# REZONE AND PRELIMINARY PLAN

ADDRESS: 3305 S FRUITLAND  
 PARCEL NUMBERS: 4005000220, 4005000320  
 GROSS ACREAGE: 8.48 AC  
 CURRENT ZONING: RS-10  
 PROPOSED ZONING: RS-04  
 PROPOSED LOTS: 52

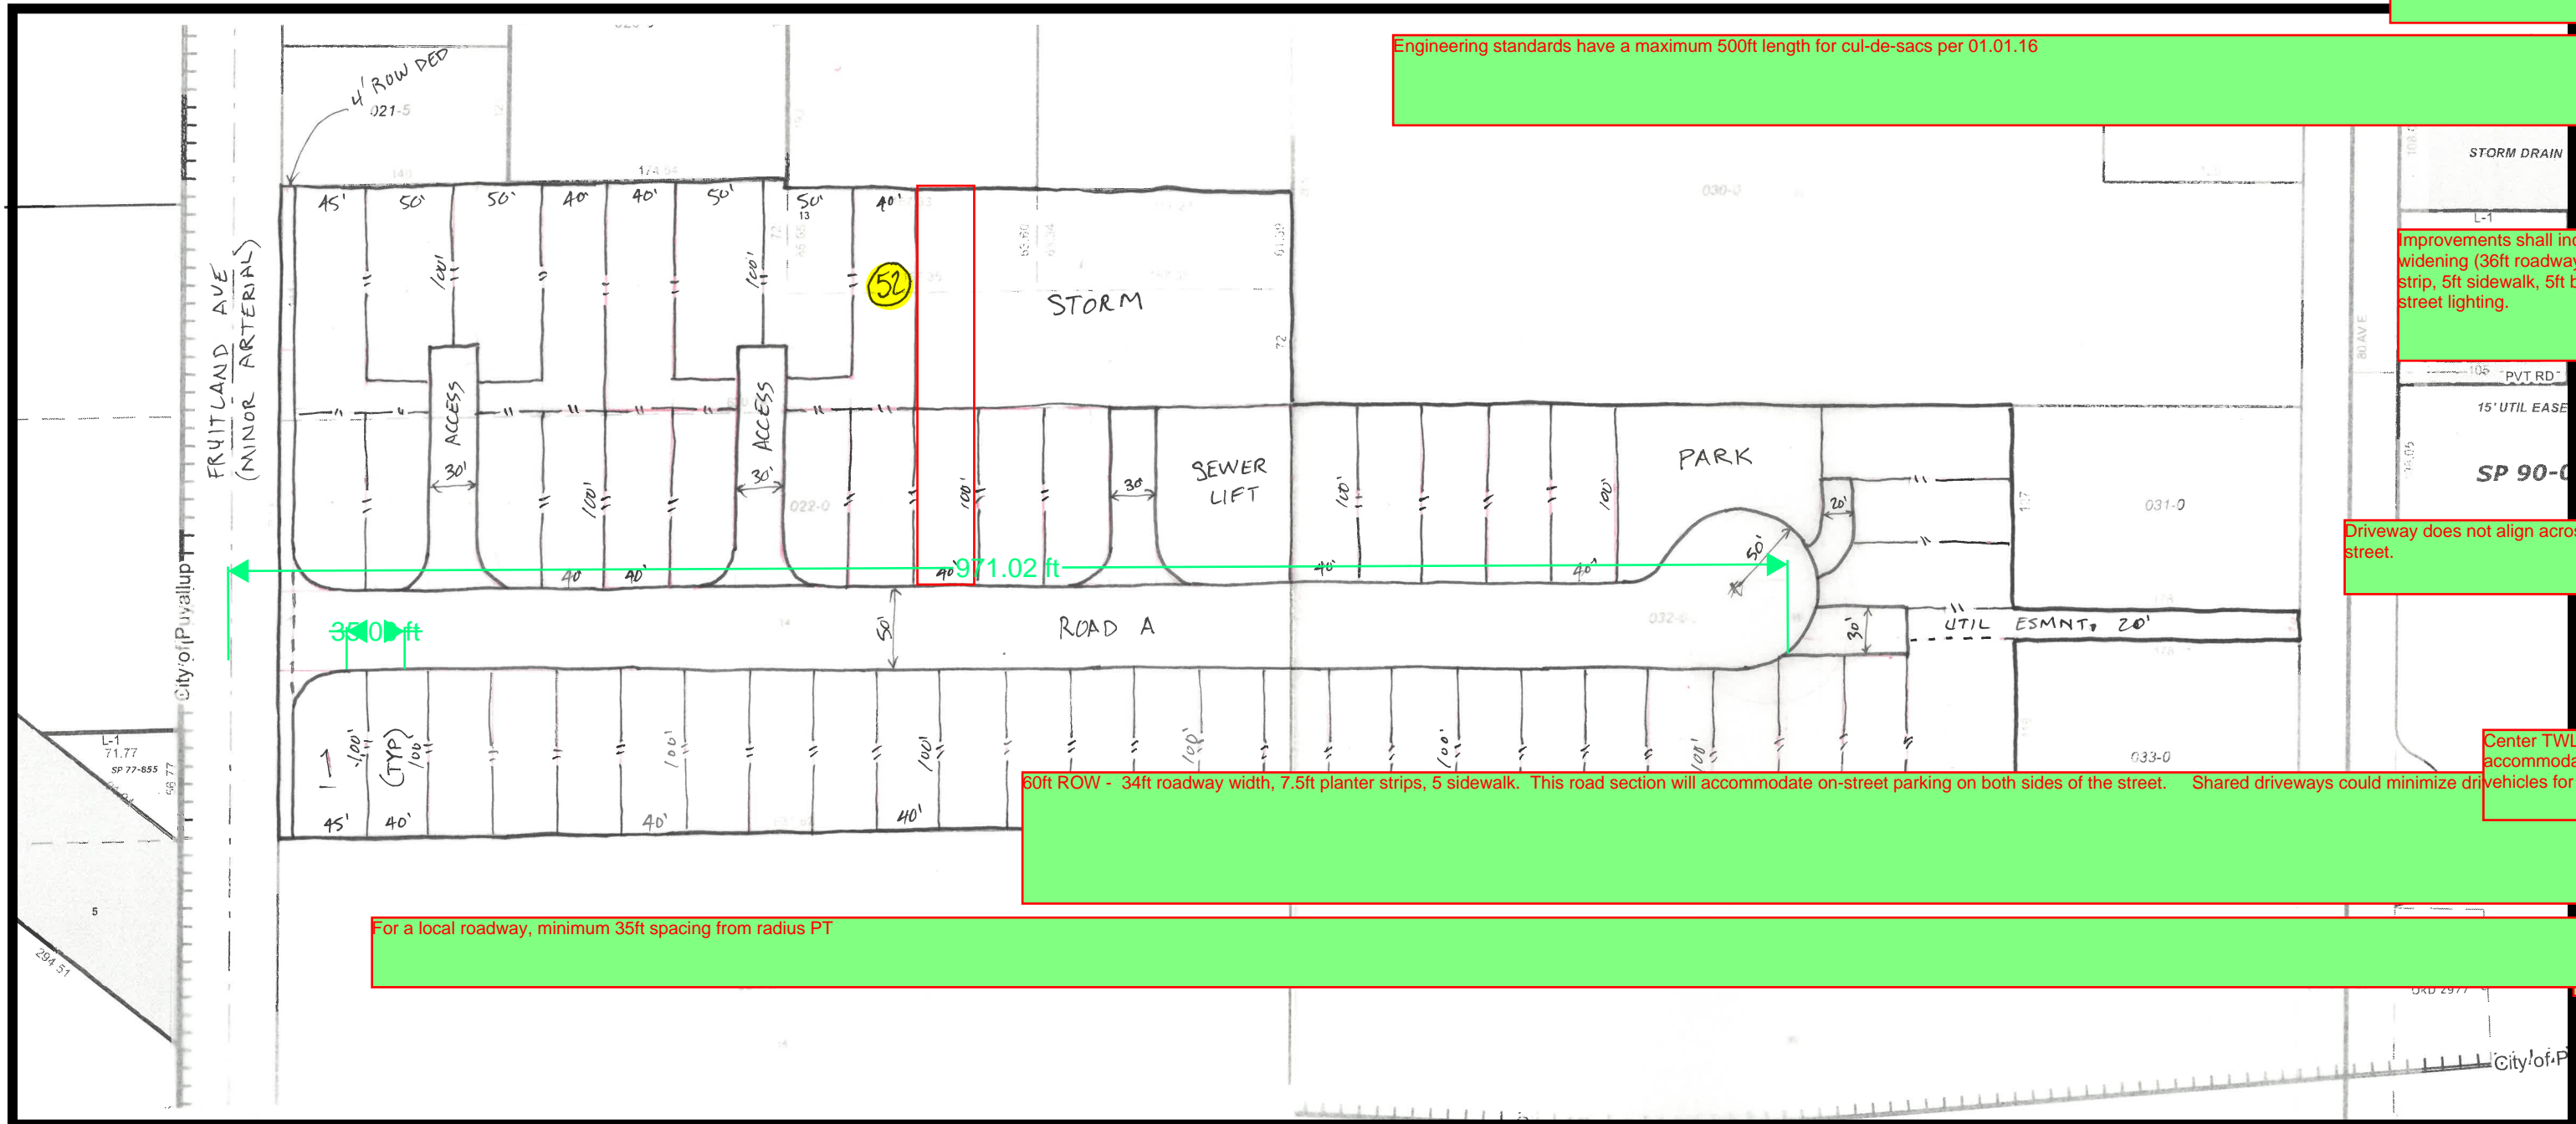
Operational analysis of 31st/Fruitland needs to account for unserved demand from excessive queuing. Analysis of peak hour vehicle throughput (traffic counts) will not represent actual vehicle delay.

City estimates ROW to be -9ft.

Engineering standards have a maximum 500ft length for cul-de-sacs per 01.01.16

Off-site paved transition from face curb

Improvements shall include road widening (36ft roadway) 10ft plan strip, 5ft sidewalk, 5ft bike lanes, street lighting.

Driveway does not align across the street.

Center TWLTL requires accommodate inbound vehicles for Arterial road

60ft ROW - 34ft roadway width, 7.5ft planter strips, 5 sidewalk. This road section will accommodate on-street parking on both sides of the street. Shared driveways could minimize driveway vehicles for Arterial road

For a local roadway, minimum 35ft spacing from radius PT
